Proposed Project Description: Construct Deck. Exterior Renovations. Signature: [Signature] Date: 12-9-89 PEDESTRIAN ACTIVITIES DISTRICT (PAD)  Approved  Approved with Conditions  Denied

# BUILDING PERMIT REPORT

DATE: 11 Dec. 98 ADDRESS: 130 Taft Ave. CBL 273-A-014  
REASON FOR PERMIT: To Construct deck 12' x 14'  
BUILDING OWNER: Sun-Neak  
CONTRACTOR: SAA  
PERMIT APPLICANT: SAA  
USE GROUP R-3 (U) BOCA 1996 CONSTRUCTION TYPE 5B

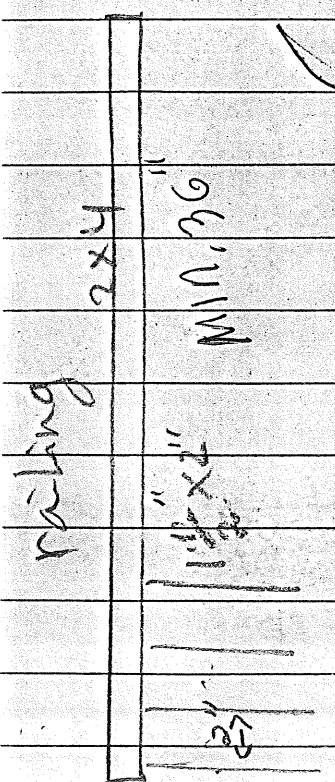
- \*30. Glass and glazing shall meet the requirements of Chapter 24 of the building code.
- \*31. Your plans did not show how the deck would be attached to the dwelling - A suggestion would be to lag bolt a 2x8 to the headers sill of the dwelling and use hanger (joists) for the floor joist.

32. The pier foundation (Soro tubes) shall be a minimum of 4' below grade, resting on and attached to the footing - The pier shall have a fastener/deck between the pier and wood framing.

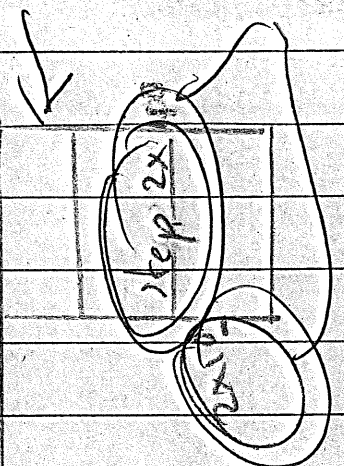
REAR Setback req: 25' - Shows 35'6"  
 Side Setback req: 14' - 23'8" min  
 (2 story bldg)  
 (over 11)

9000 sq ft x 25% = 2250 sq ft MAX
